U.S. Army Corps of Engineers Final Environmental Impact Statement for the Savannah River Navigation Maintenance (September 1976)

OPERATION AND MAINTENANCE OF NAVIGATION PROJECT
SAVANNAH RIVER BELOW AUGUSTA
INCLUDING THE NEW SAVANNAH BLUFF LOCK AND DAM
GEORGIA AND SOUTH CAROLINA

U.S. ARMY ENGINEER DISTRICT, SAVANNAH
CORPS OF ENGINEERS
SAVANNAH, GEORGIA
SEPTEMBER 1976

PLATE C-1

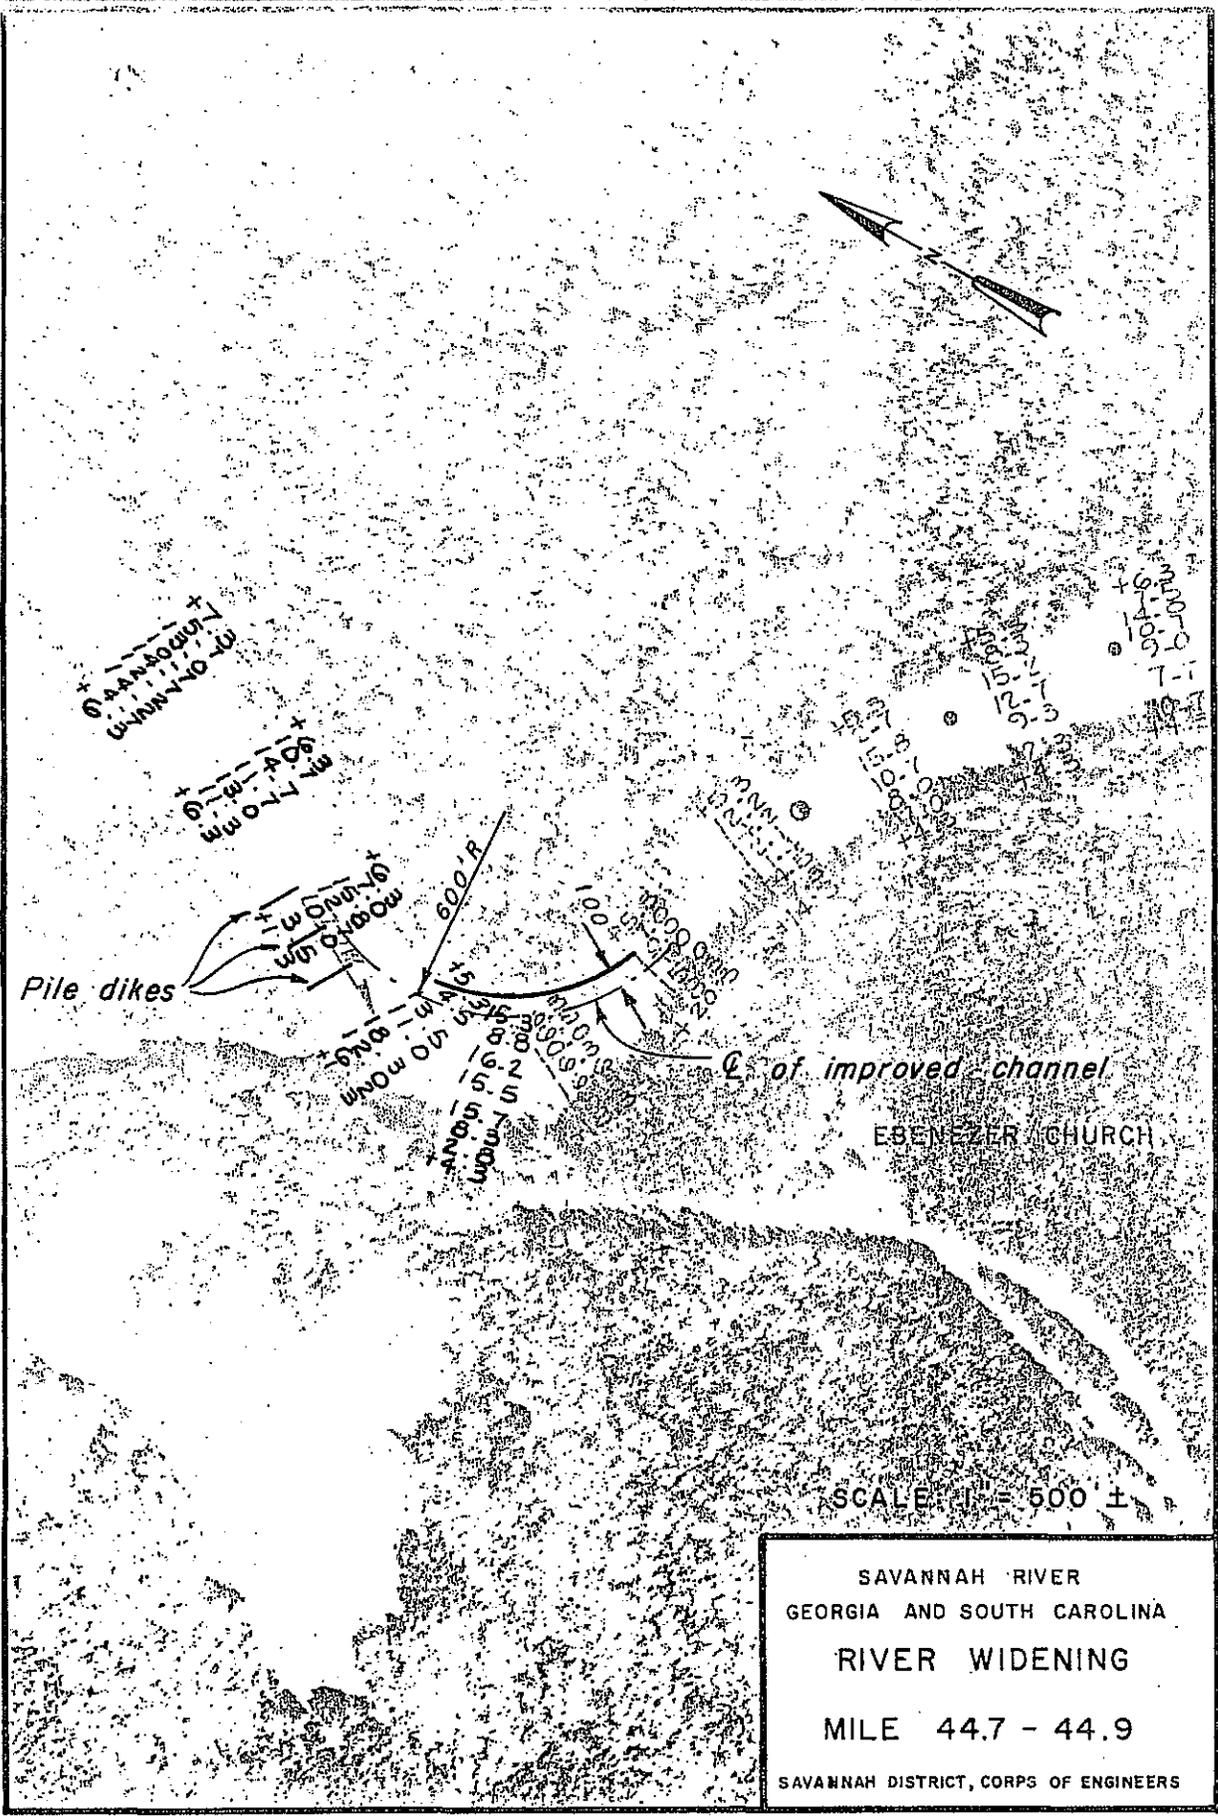
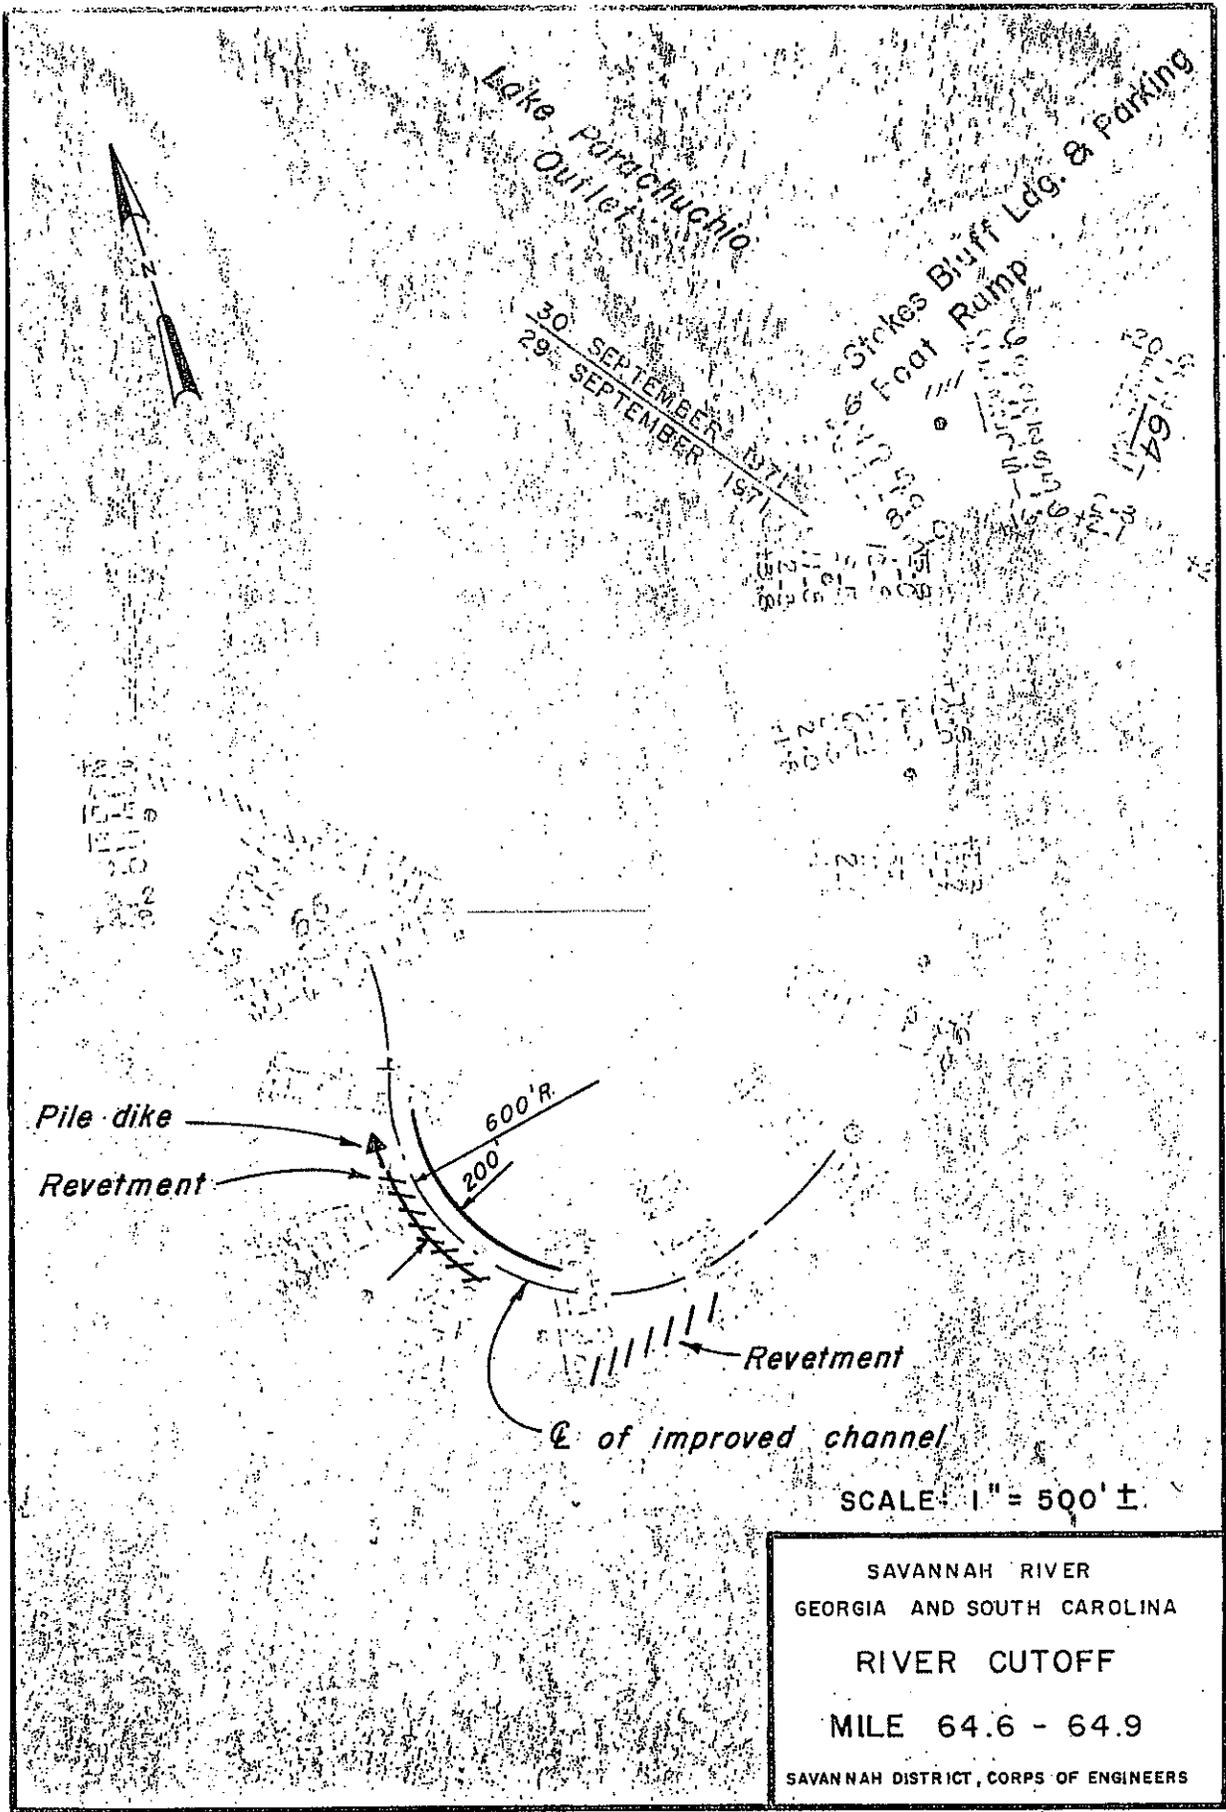
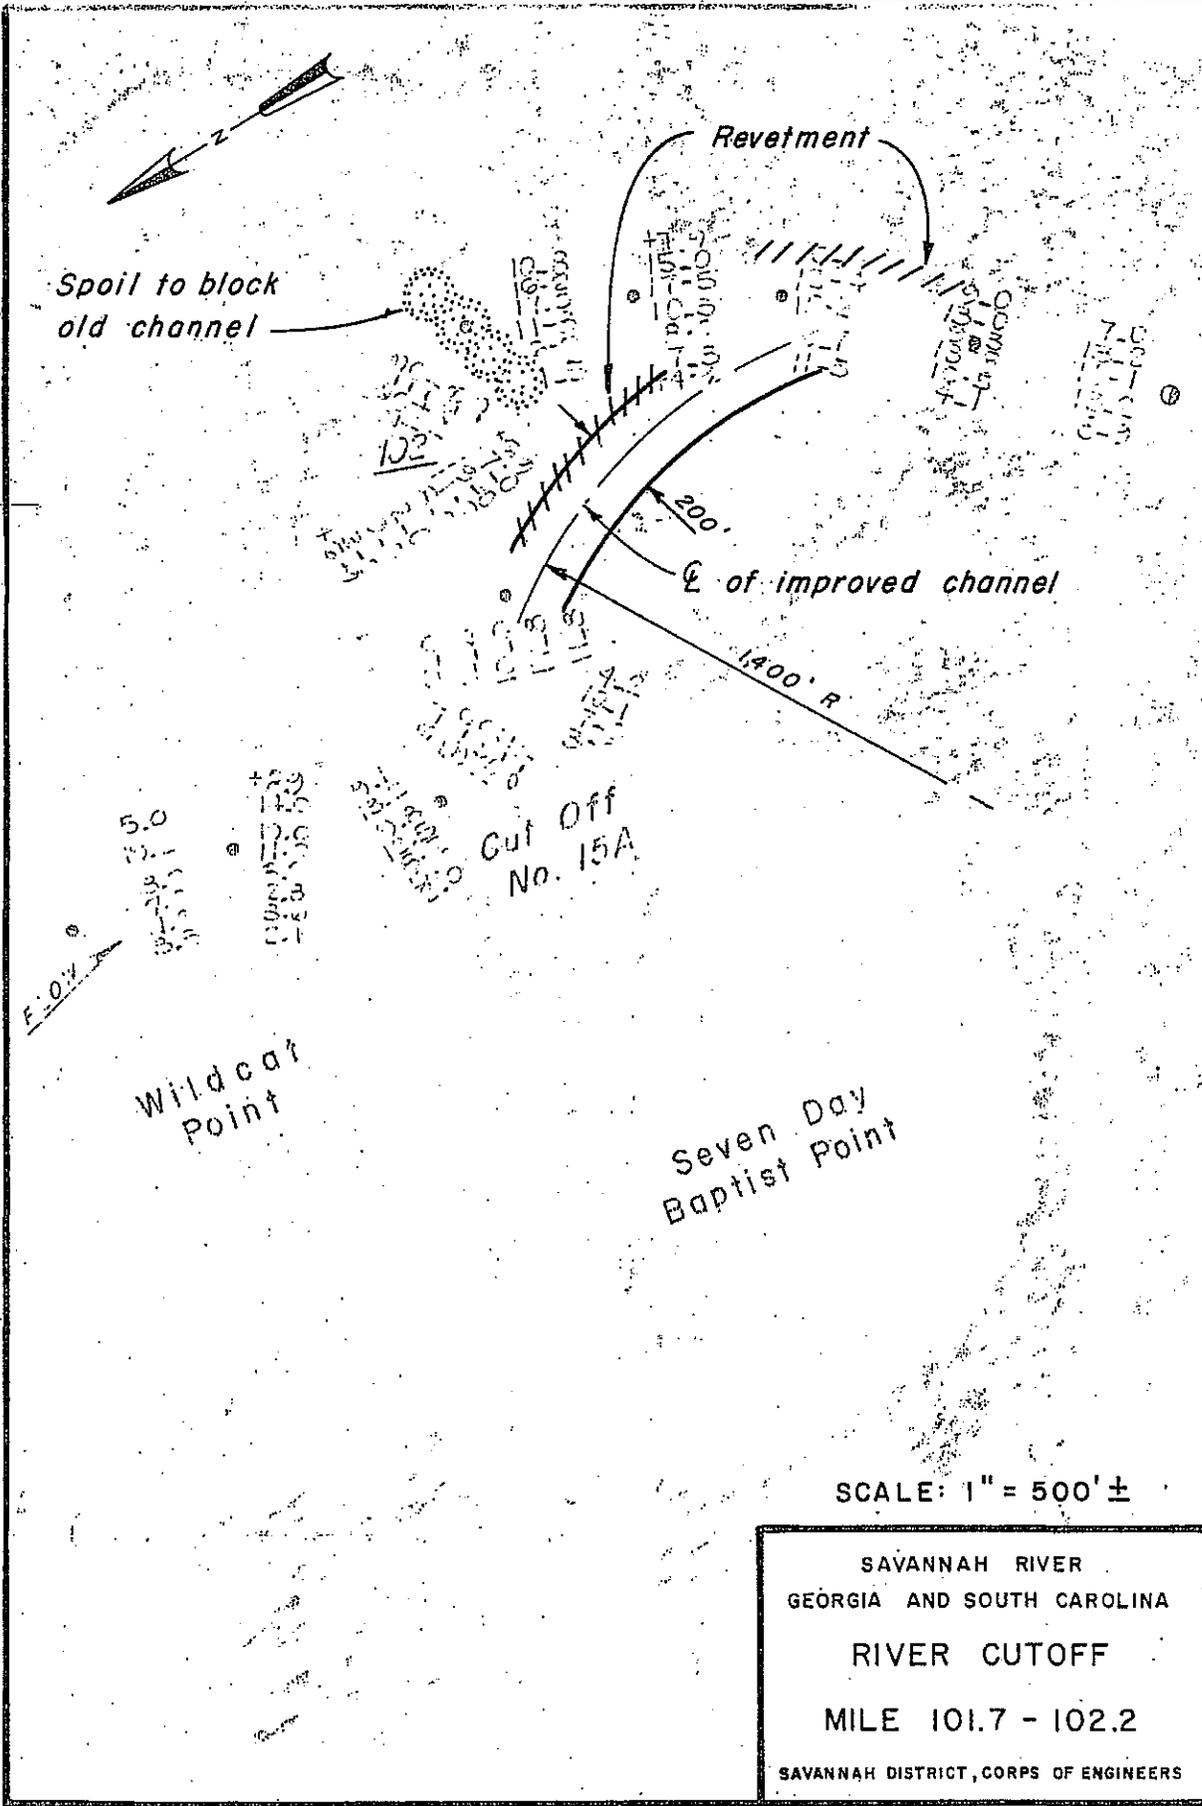
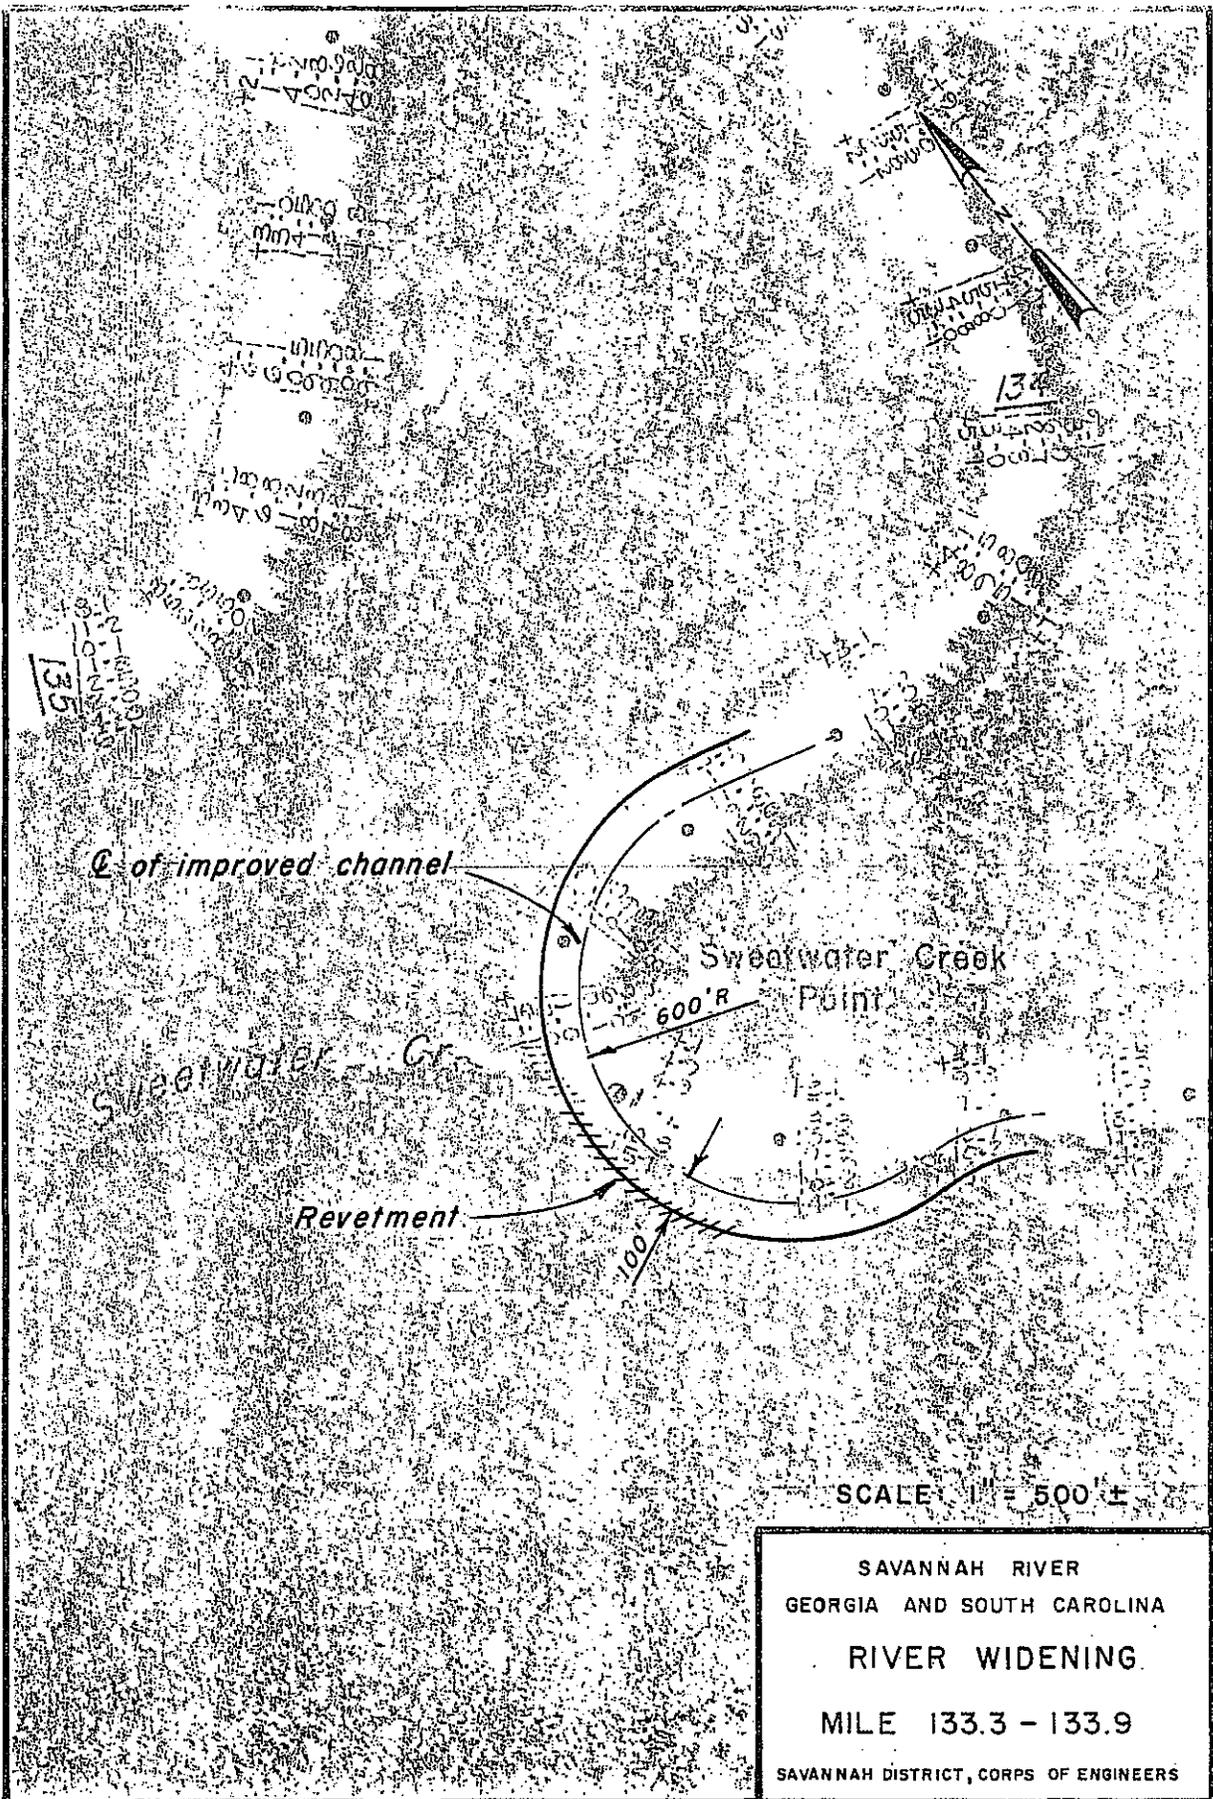
9.28 Comment: 1.00 Project Description, Page 3, paragraph 1.06, Proposed Action. This section should be expanded to include a detailed discussion of dredging methods, time of dredging, location of spoil disposal areas, construction details for additional pile dikes and revetments, and areas proposed for widening and river cutoffs. Additional figures illustrating the above features would facilitate review.

9.30 Comment: 4.00 Environmental Impact of the Proposed Action, Page 18, paragraph 4.05, Biological Impact. This section should be expanded to address specific areas designated for dredging, spoil disposal, construction of pile dikes and revetments, and areas proposed for widening and river cutoffs. The potential biological impacts will undoubtedly vary from site to site, depending on activities proposed and biological communities present.

9.35 Comment: The statement does not adequately describe location or extent of proposed river cutoffs, river widening, and the impact of the proposed construction on the associated wetland areas along the river.

9.29 Response: The dredging methods to be used in areas requiring the most intensive maintenance or construction have been added to Section 1.00 and the locations are shown on the plates of Appendix C of the Final Statement. The dredging will normally occur during the summer months due to the low water generally occurring during this time. Figure examples of typical pile dikes, river cutoffs, revetments, and general riverbend improvement have also been added in Appendix F of the Final Environmental Statement.

9.31 Response: Table 1 and the plates in Appendix C have been included in the Final Statement to give the locations of areas requiring the most intensive maintenance work. The potential biological impacts will vary from site to site; however, the general impacts will be about the same for all areas.

9.36 Response: The areas requiring the most intensive maintenance are presented in Table 1 and their locations are shown on the plates of Appendix C of the Final Environmental Statement. These modifications will not directly affect any of the wetlands along the Savannah River.
